CHANGE ORDER NO. 11

PROJECT: West Sewage Treatment Plant (STP) Improvements  
 OWNER: City of Crest Hill, Illinois  
 CONTRACT: 1-2022  
 CONTRACTOR: Vissering Construction Company

Project: CITY OF CREST HILL - WEST SEWAGE TREATMENT PLANT IMPROVEMENTS

Cost Proposal Request  
West Sewage Treatment Plant Improvements  
City of Crest Hill  
Contract 1-2022  
August 26, 2025

**Drawing 99-E6.03 - Electrical SCADA Riser Diagram**

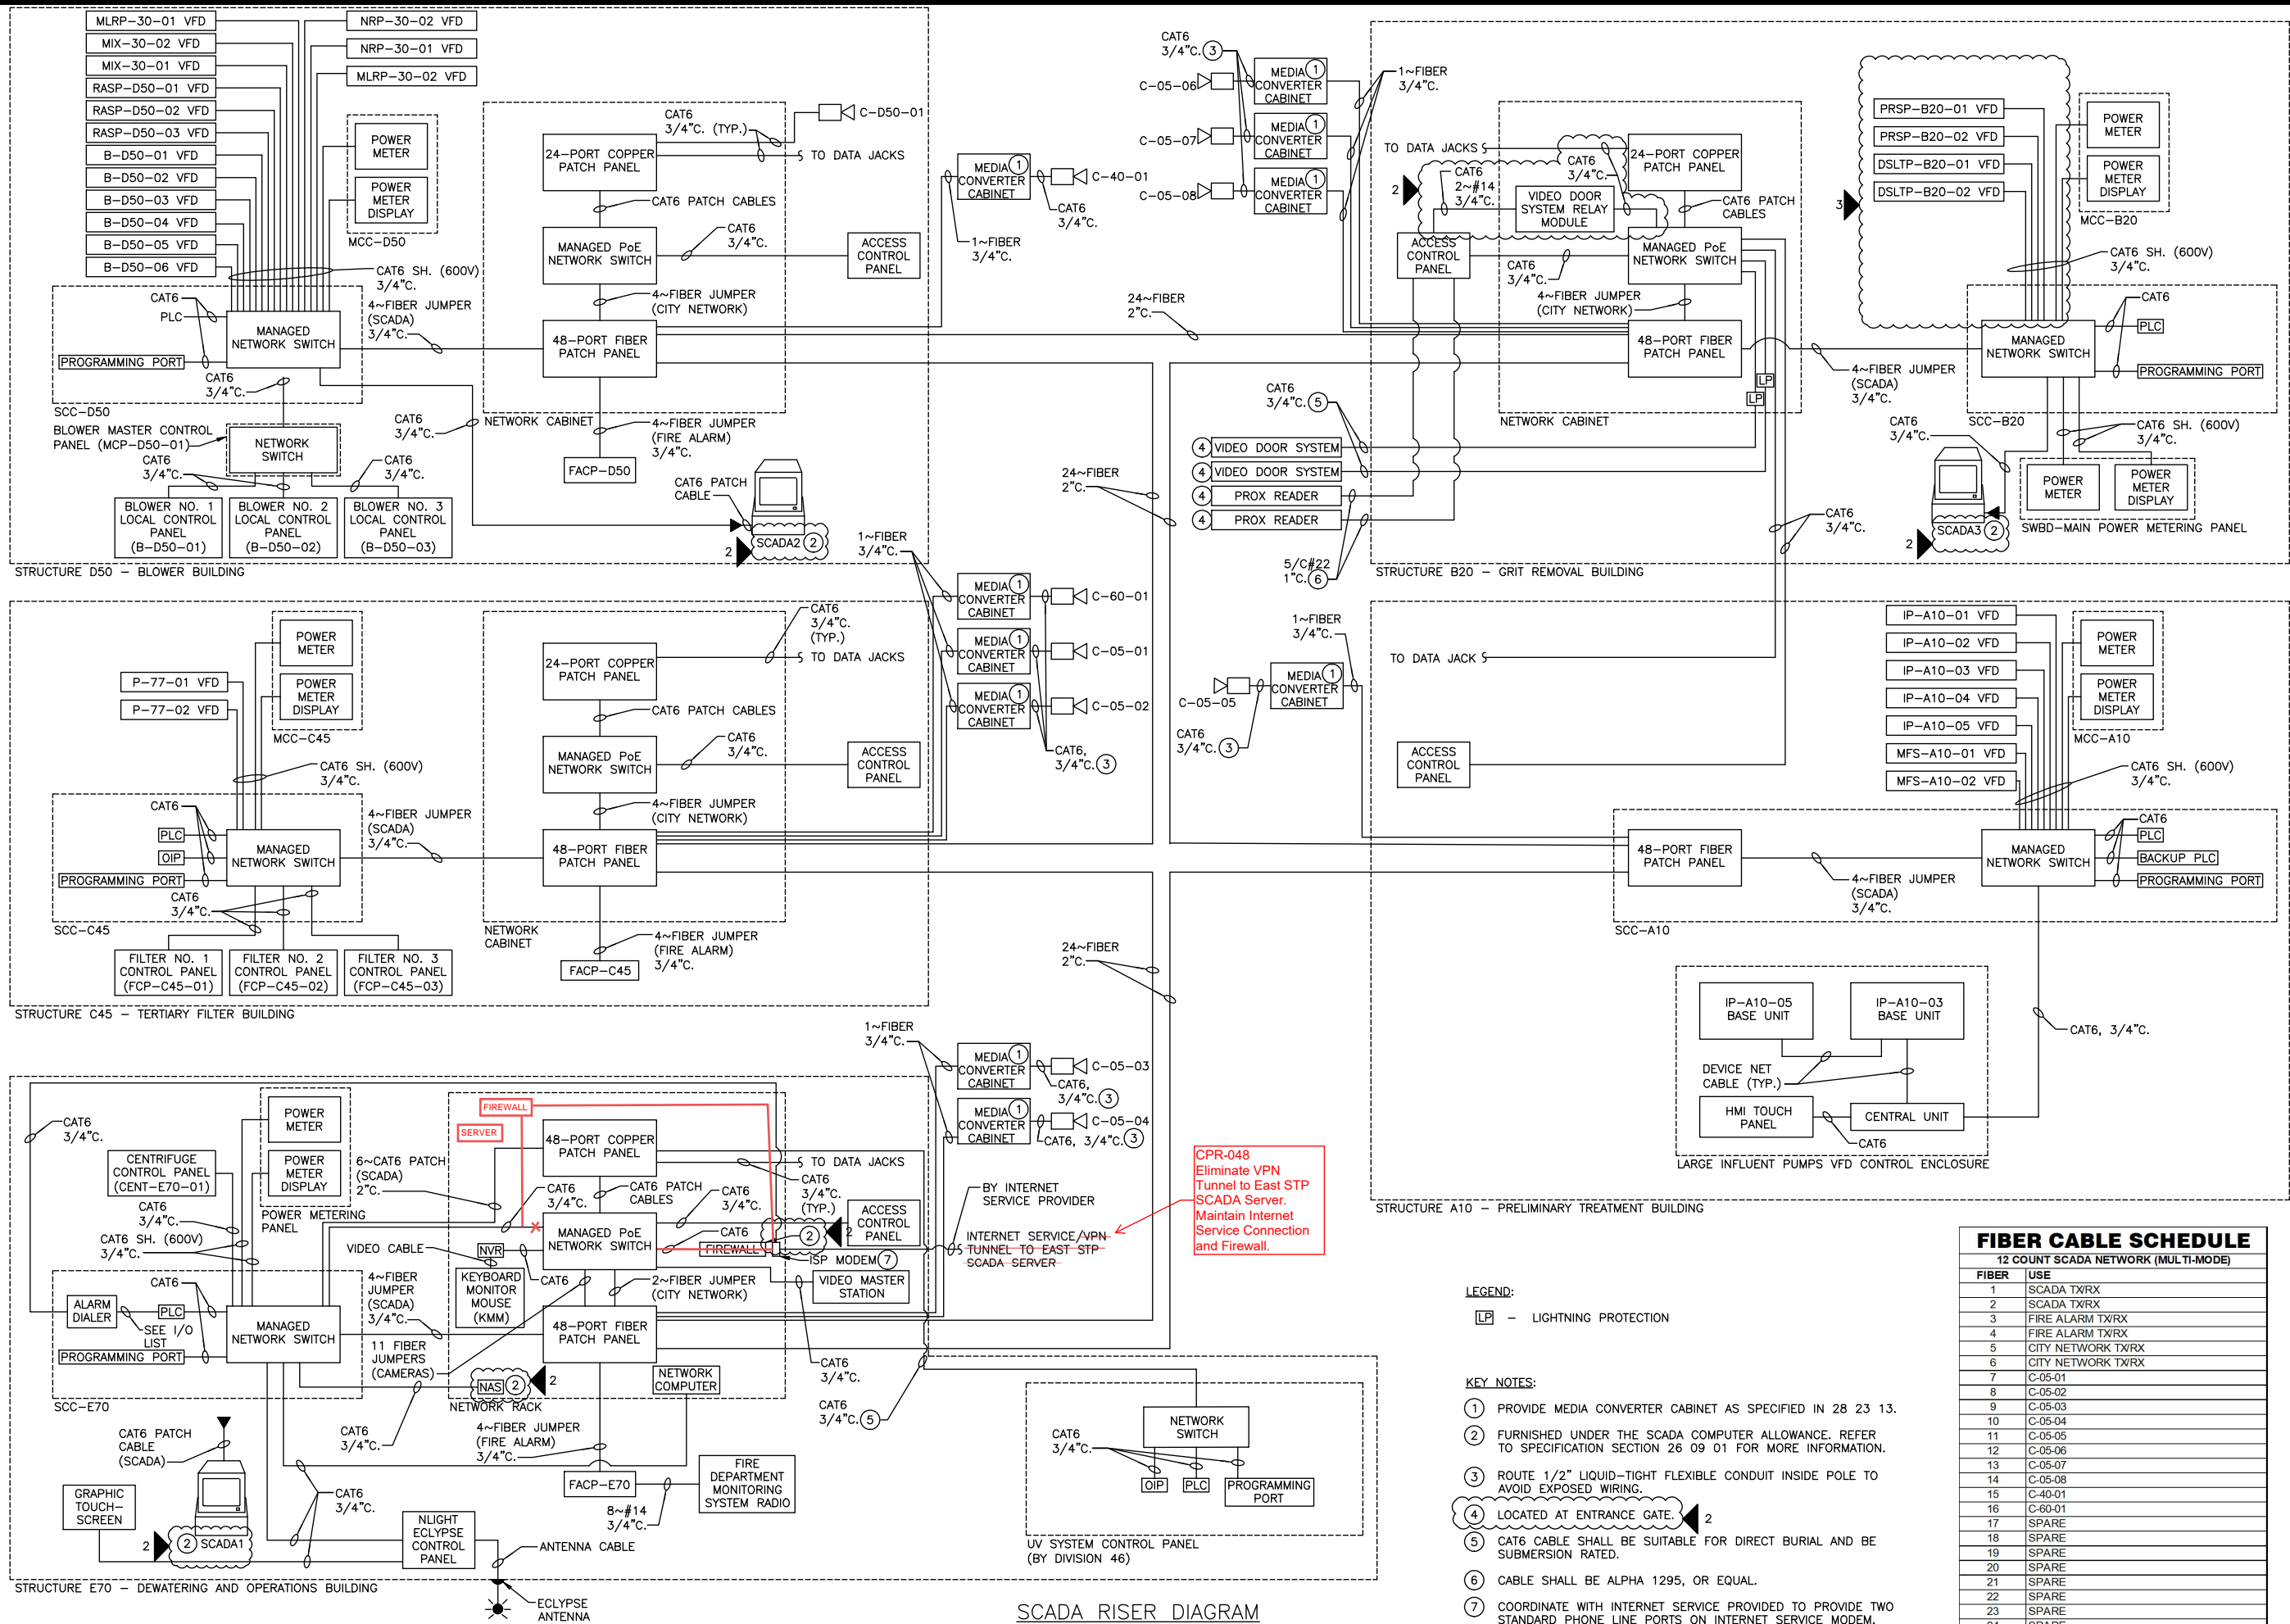
048-05 See attached mark-up.

**Drawing 99-E6.03 - Electrical SCADA Riser Diagram**

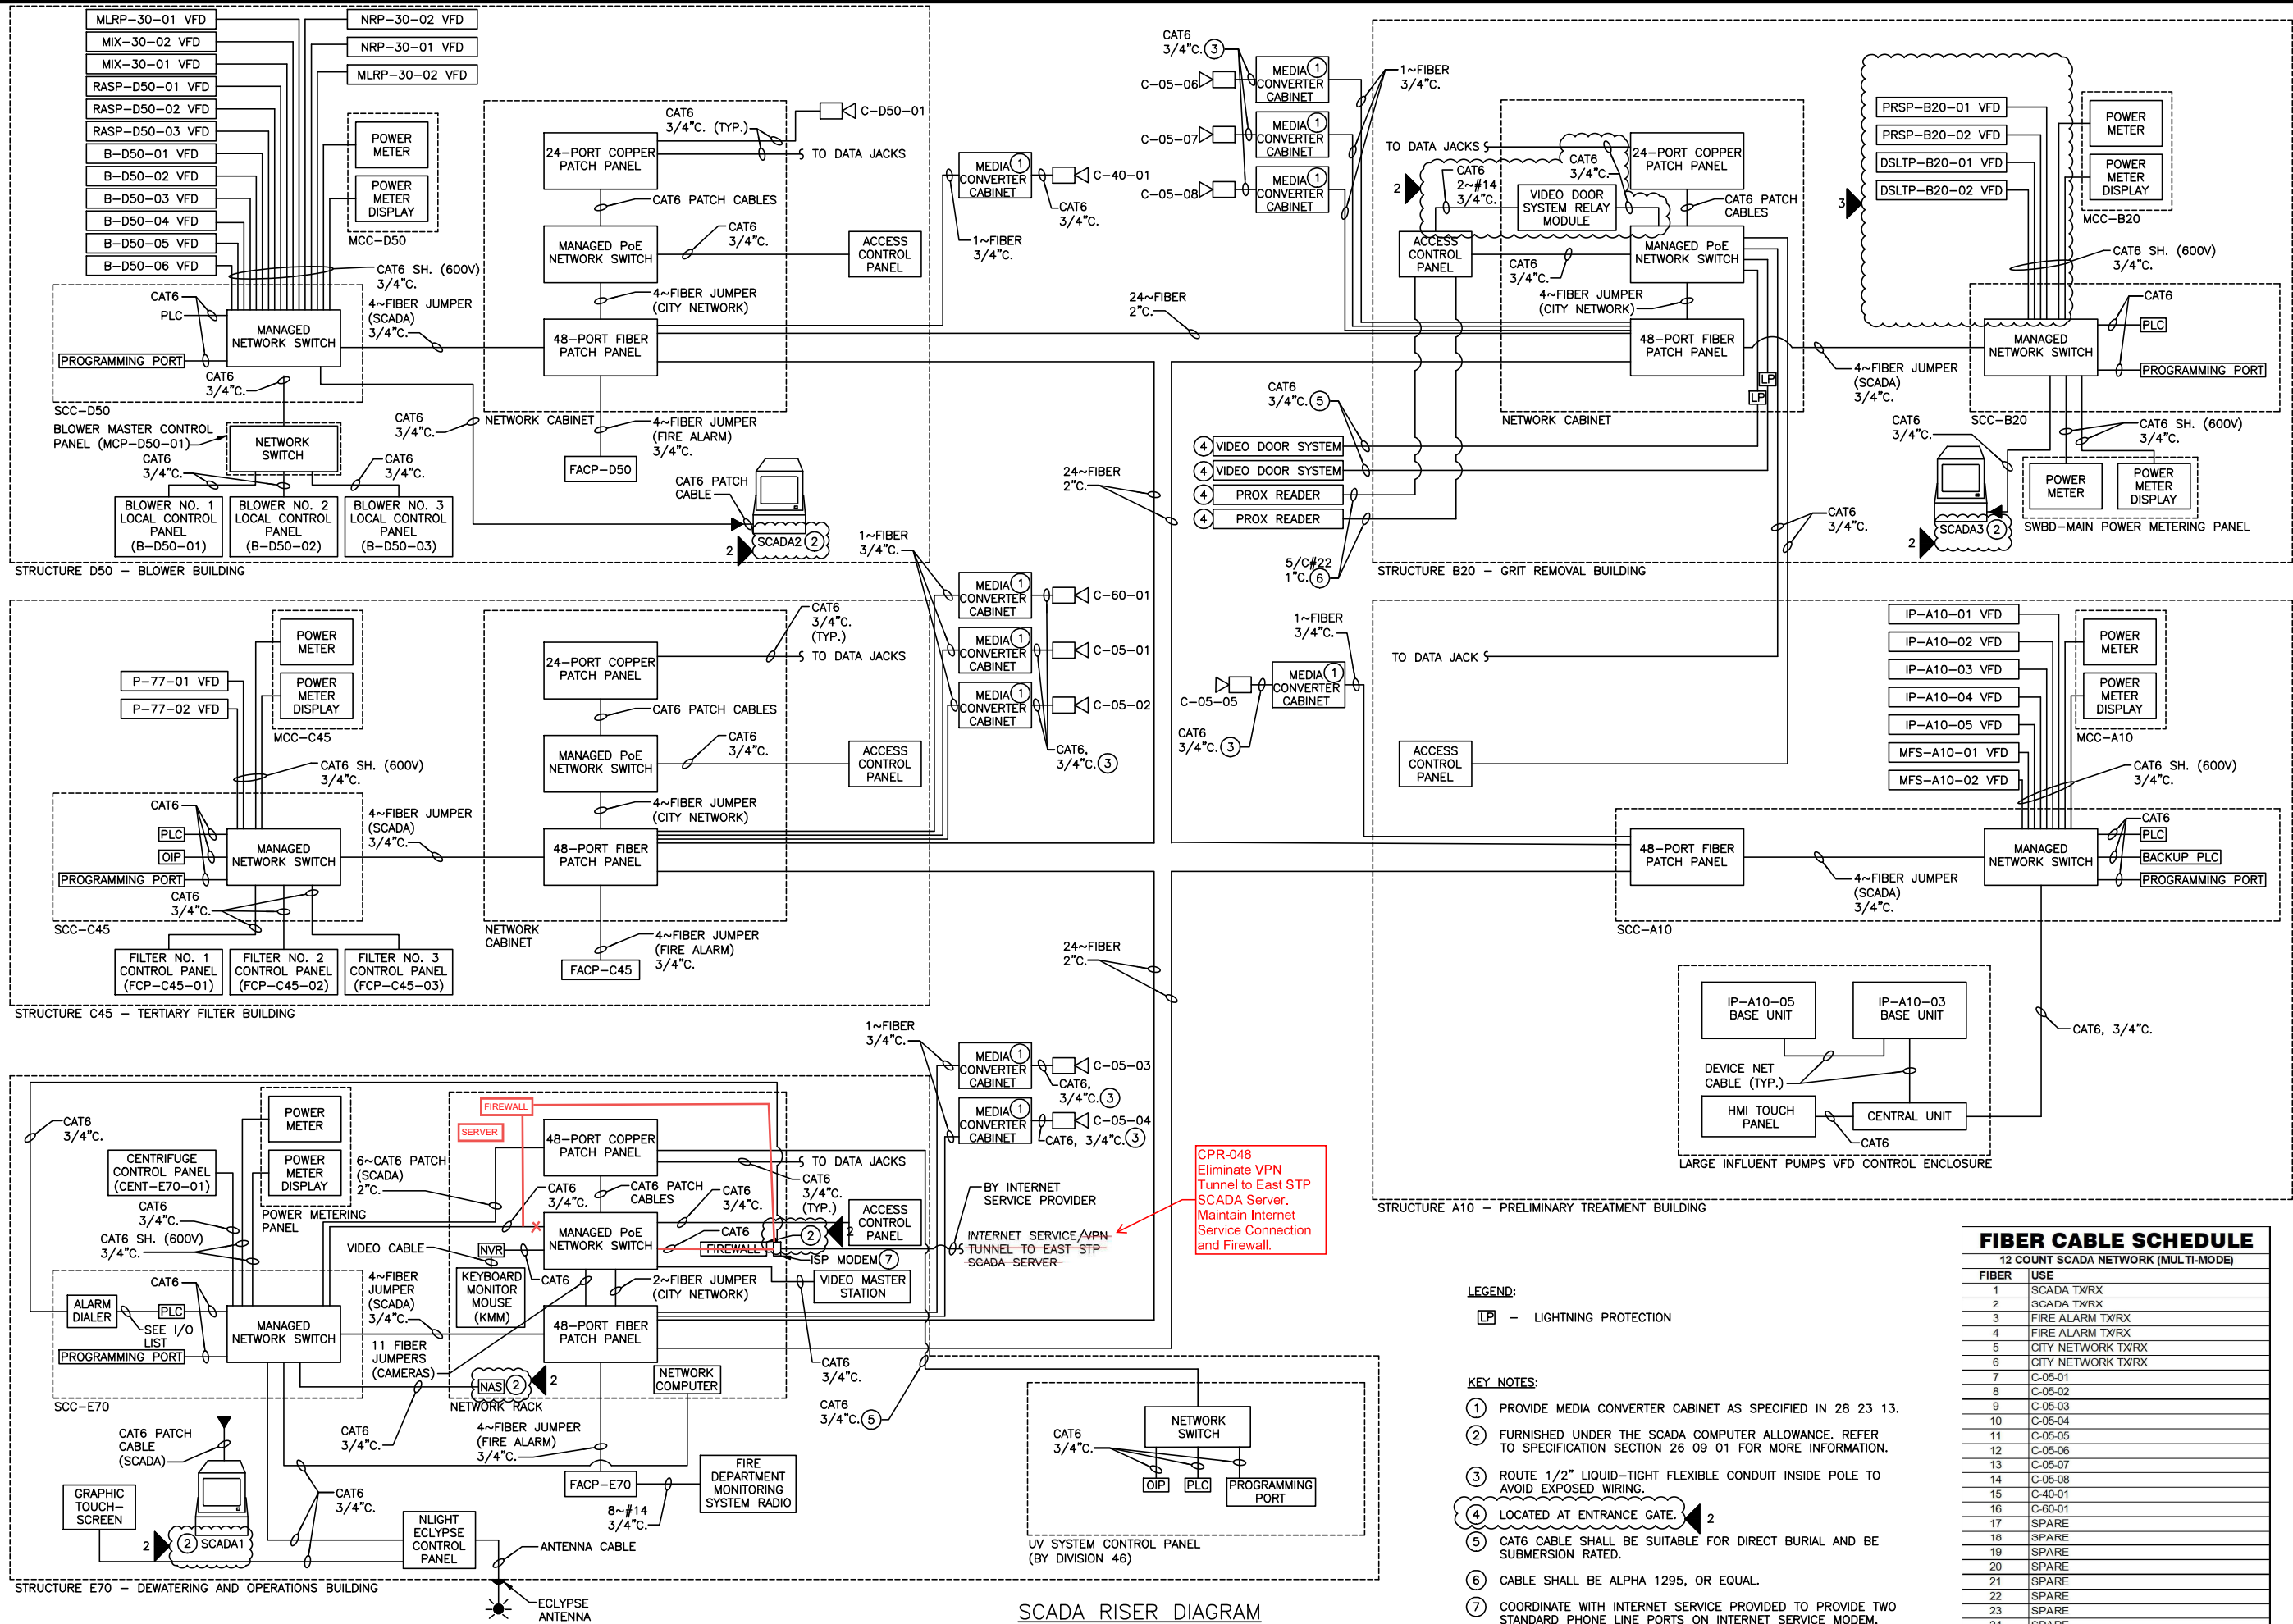
048-05 See attached mark-up.

SHEET 130 C45-E1.01

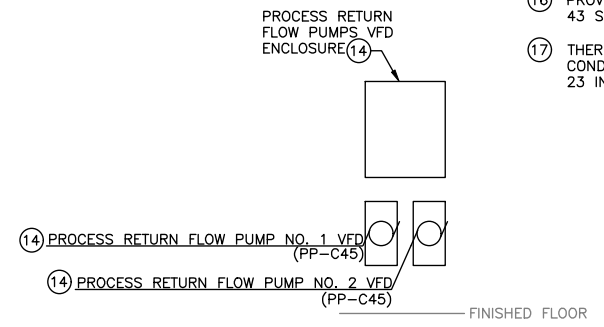
**Drawing C45-E1.01 - Tertiary Filter Building - Electrical Plan**

052-01 Provide emergency stop pushbutton in NEMA 4X control station enclosure by Tertiary Disc Filter manufacturer and 2~#14 in 3/4" conduit from each e-stop to the associated filter control panel. Pressing the e-stop shall stop backwash pump, filter drum drive, and spray bar oscillating motor of its respective filter. Provide panel modifications as required. See attached mark-up.

**Drawing C45-E1.01 - Tertiary Filter Building - Electrical Plan**

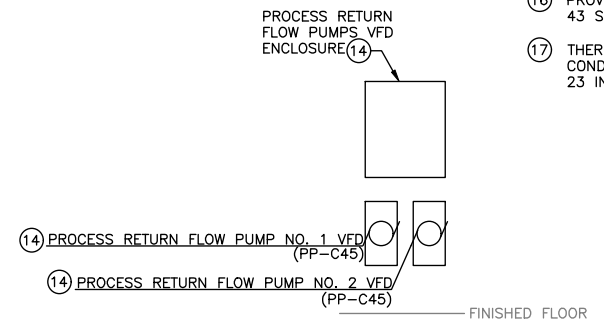
Please submit an itemized quotation for changes in the Contract Price and Time incidental to proposed modifications to the Contract Documents described herein. The purpose of this request is to add additional emergency stop push buttons nearer the tertiary filter equipment.
